SECTION II. PLANNING COMMISSION DECISION

The Planning Commission finds the proposed application does not meet the applicable approval criteria of the Tigard Community Development Code. Therefore, the Planning Commission **DENIES** the requested Land Use Application.

The applicant is requesting concurrent approval of a quasi-judicial zoning map amendment and a 53-lot subdivision for single-family homes. The zoning designation would change from R-12 to R-7; both are allowed under the existing Medium Density Residential Comprehensive Plan Designation, so the map change remains a quasi-judicial action by the Planning Commission. Existing street stubs would be extended into the site, and a new street entrance onto Hall Boulevard would be created. The project site represents the largest undeveloped lot within this zoning district, and approximately 27% of the available R-12 lands outside of the River Terrace area (2014 Buildable Lands Inventory).

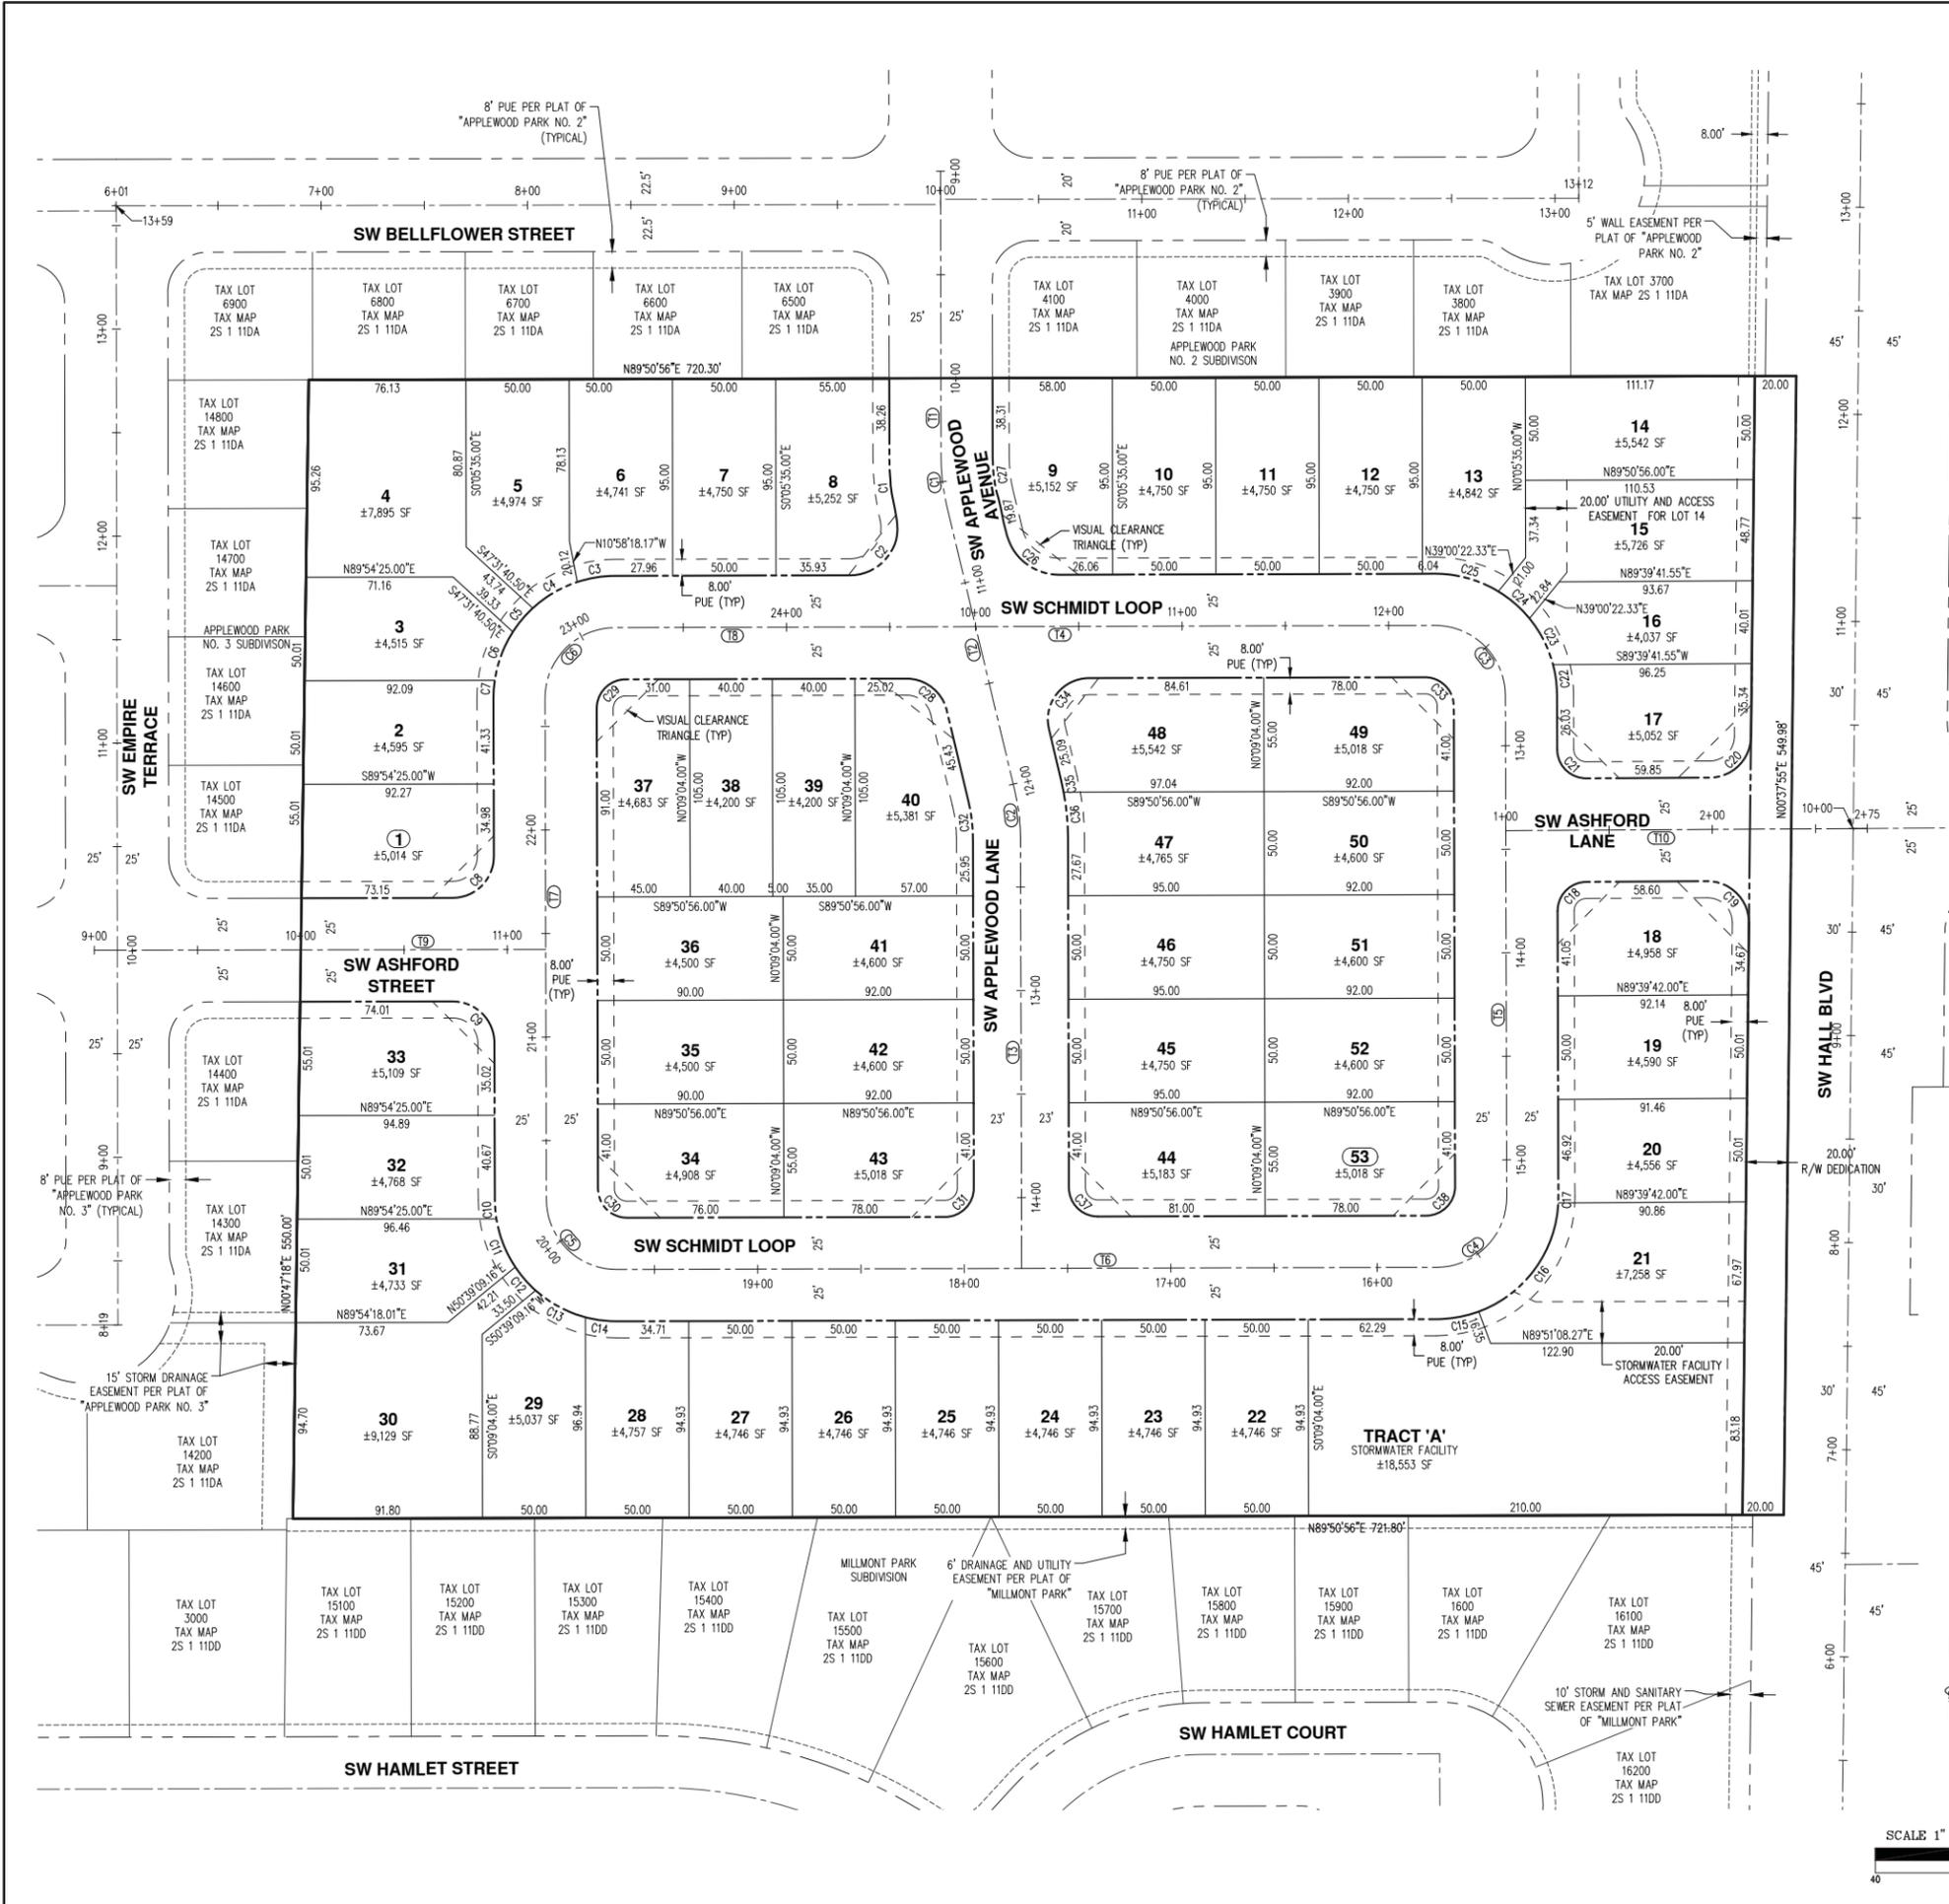
Applewood Lane and Applewood Avenue show centerline radii as 59 feet however the standard is a minimum of 166 feet. The applicant has requested an adjustment to the local street standards for Ashford Street and Applewood Avenue. The adjustment would allow existing sidewalk adjacent to the curb to continue a short distance to Schmidt Loop.
